Submission of Further Information (FI)

**Temporary Animal Boarding Establishment with Ancillary Facilities and associated
Filling of Land for a period of 5 years in "Agriculture" Zone,
Lot Nos. 1493 (Part) and 1500 (Part) in D. D. 107 and Adjoining
Government Land, Yuen Long, New Territories
(Application No. A/YL-KTN/1177)**

Further Information for Planning Application No. A/YL-KTN/1177**Response-to-Comments****Comments from Drainage Services Department**

Viewpoint 10

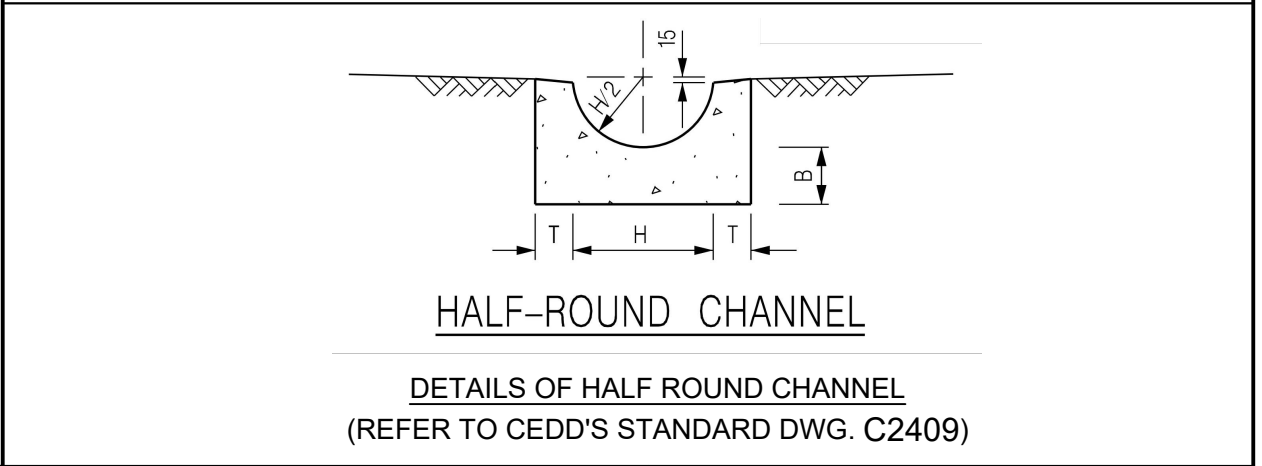
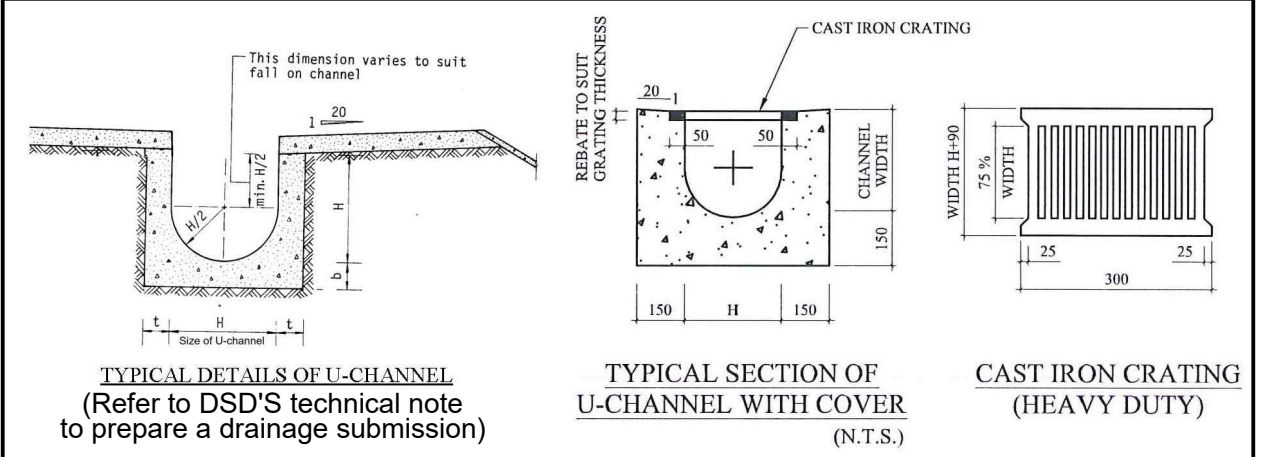
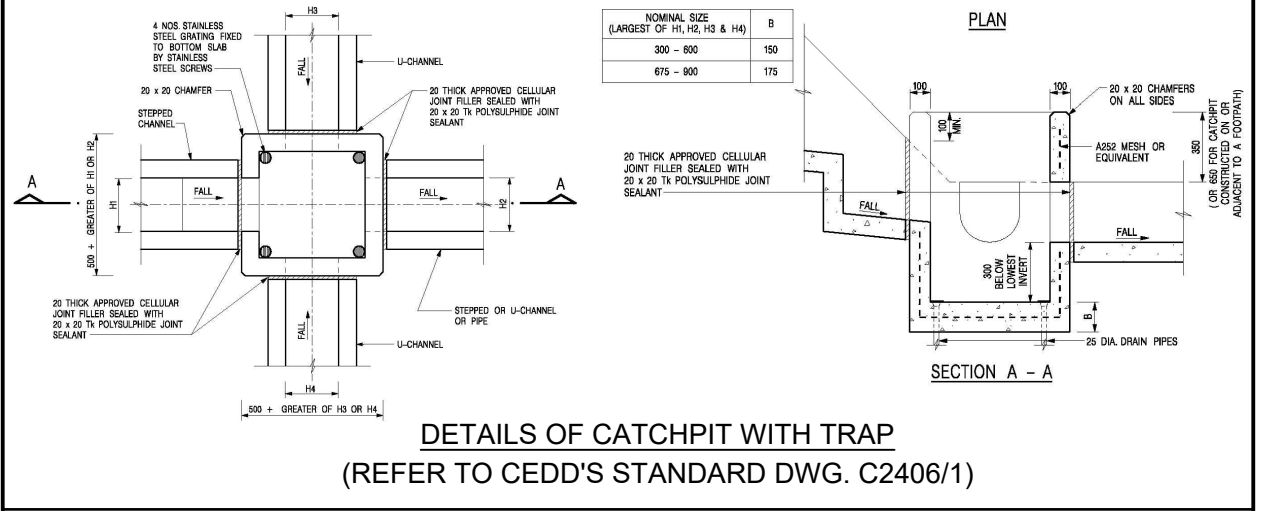
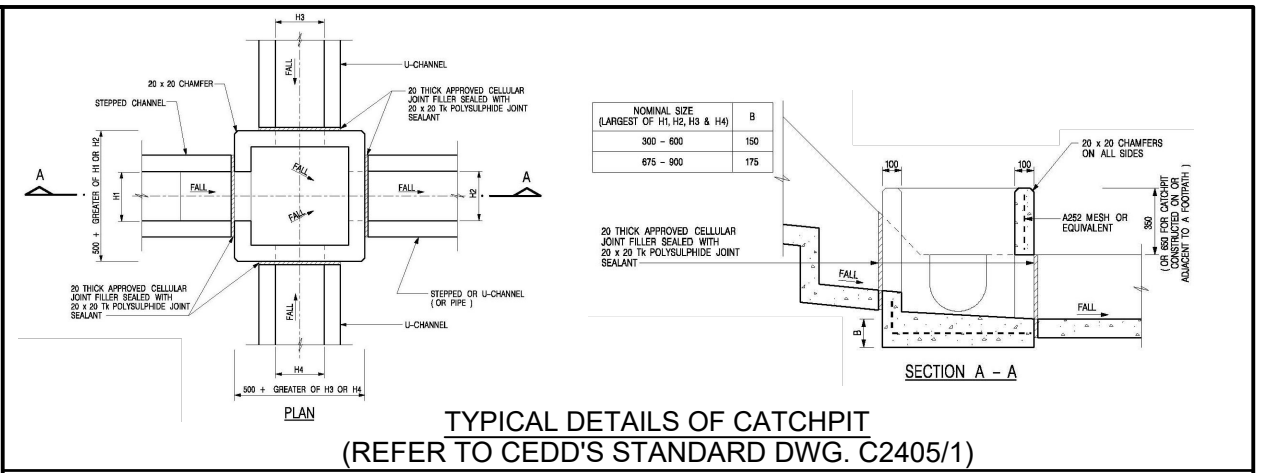
2.	Peripheral surface channels shall be provided along the site boundary to collect the surface runoff accrued on the application site and to intercept the overland flow from the adjacent lands. It is noted that there is proposed land filling works for the development. Proper surface channels should be provided at the lower level and wall toe to collect the overland flow to/from adjacent areas.	Peripheral surface channels are provided along the site boundary to collect the surface runoff accrued on the application site and to intercept the overland flow from the adjacent lands. Please refer to the attached viewpoint photograph 10.

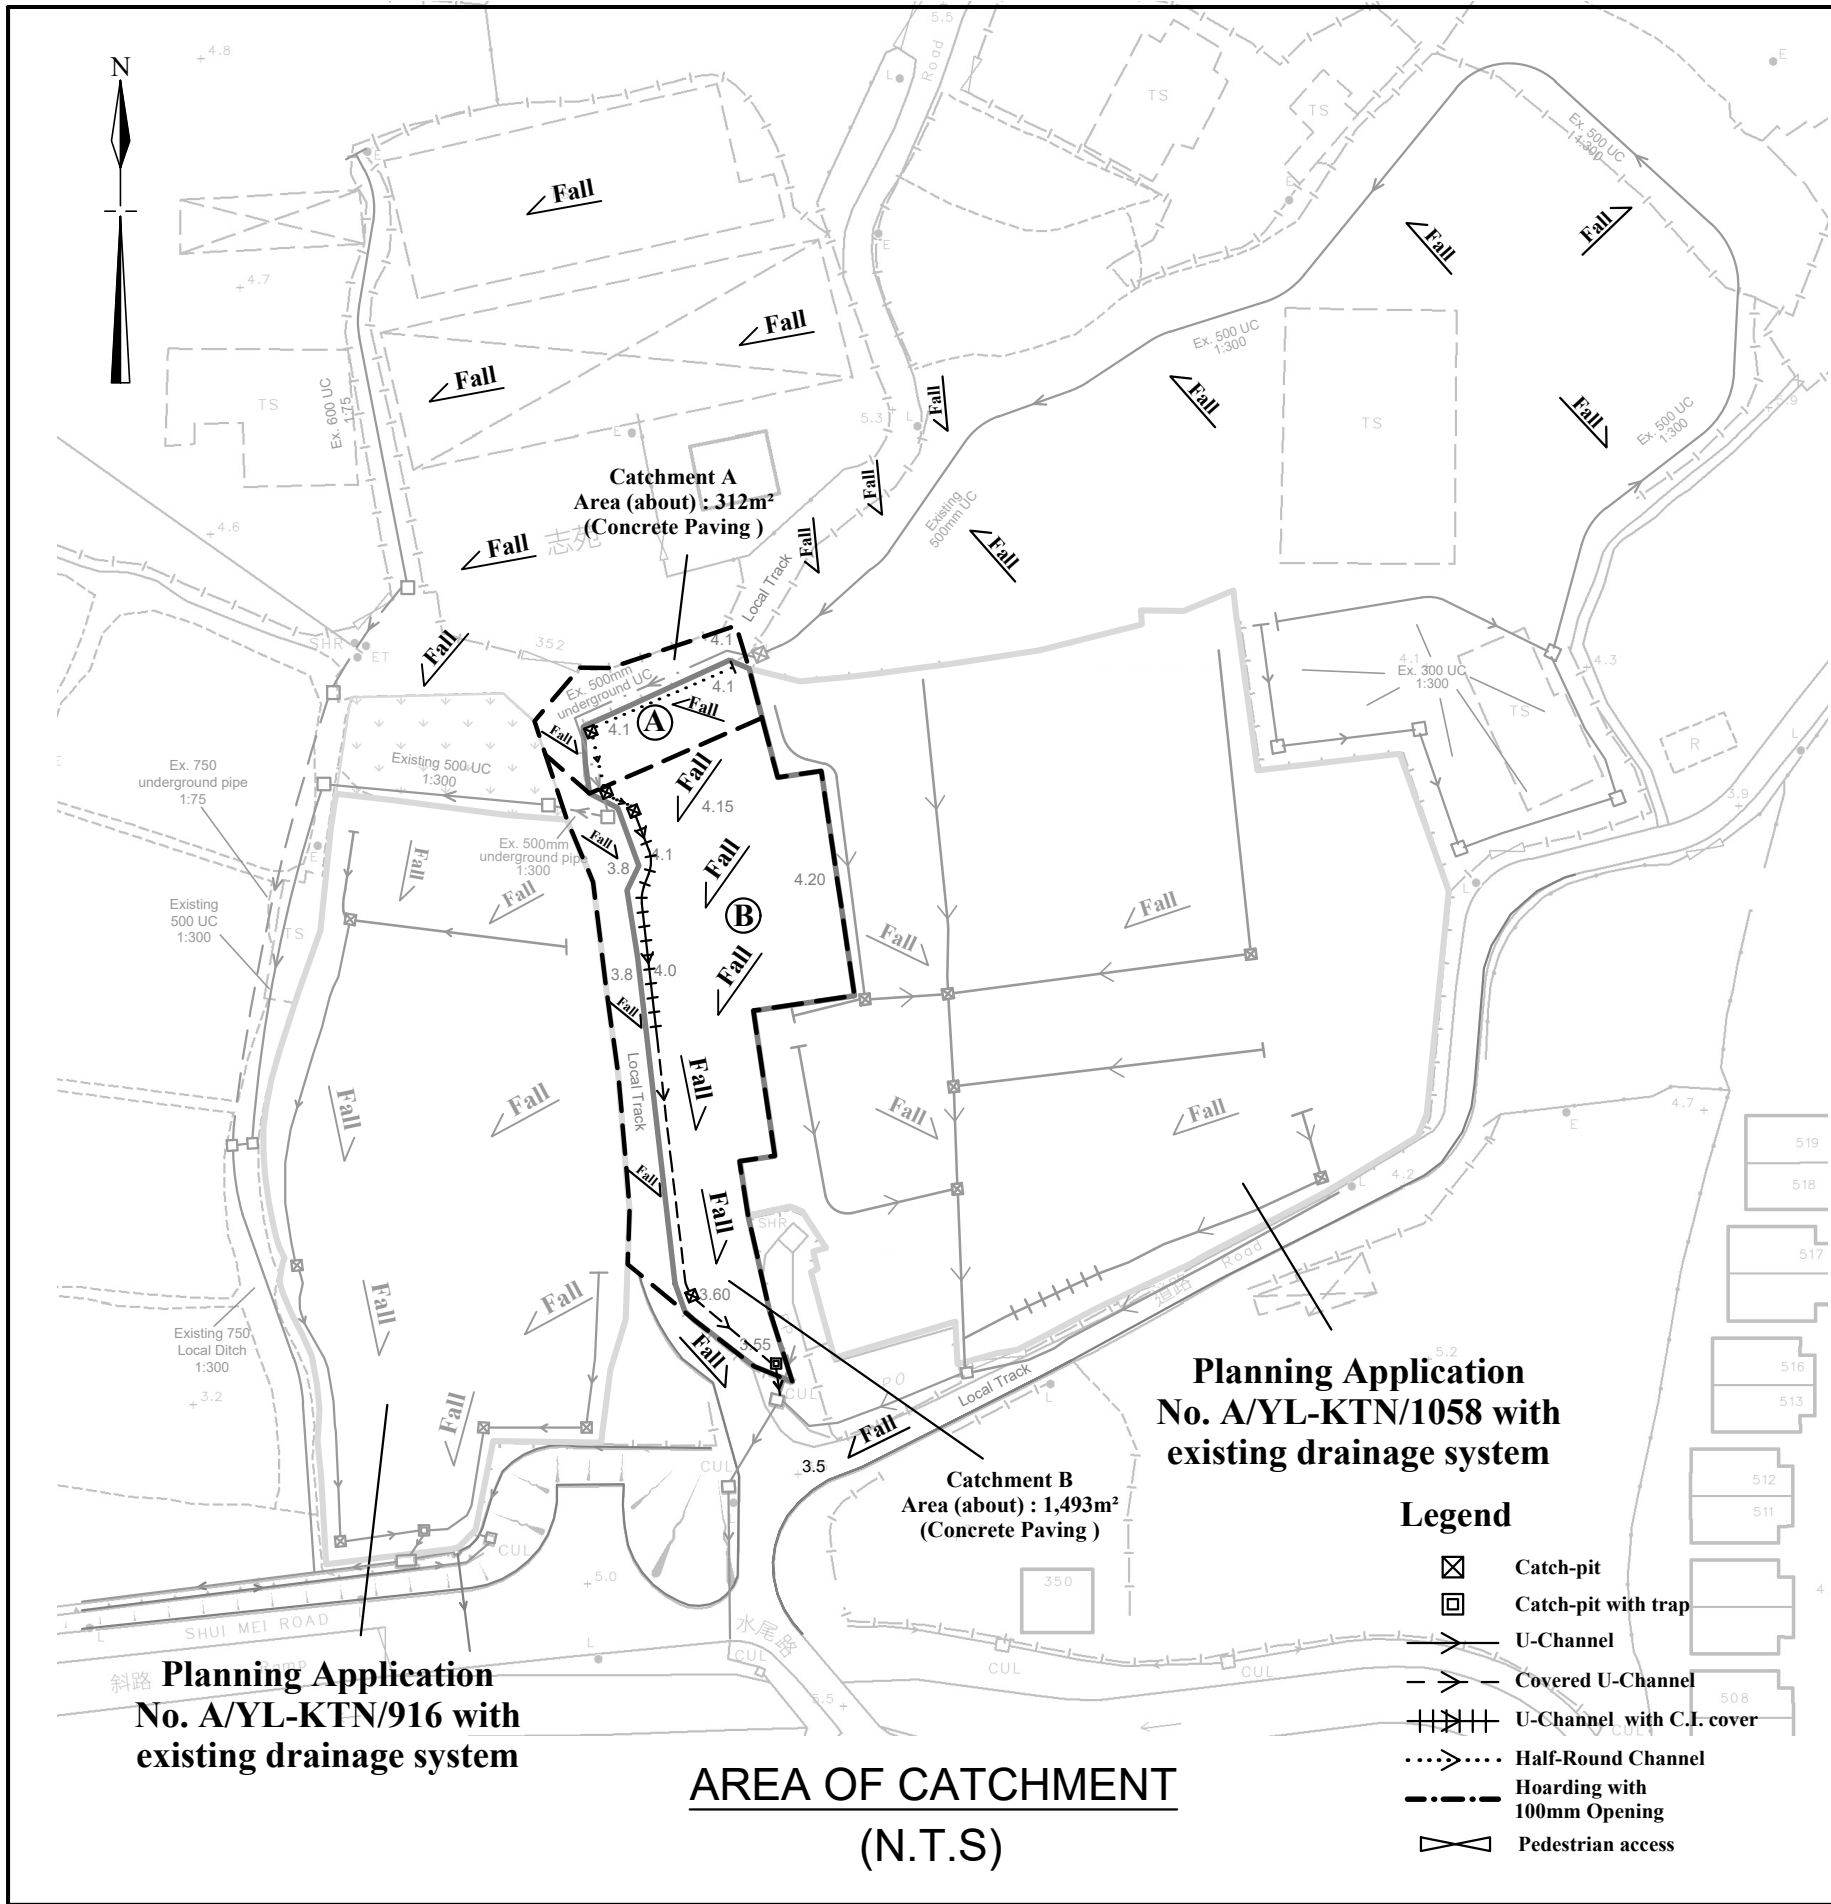
I.	Comments	Responses
1.	Plan 6.1b: The applicant should review alignment of the proposed drainage facilities connecting catchpits CP2 and CP4.	The alignment of the drainage facilities connecting catchpits CP2 and CP4 is reviewed. Please refer to Plan 6.1b.

12.	Consideration should be given to provide grating for the surface channels.	Grating is provided for the surface channels. Please refer to Plan 6.1b.
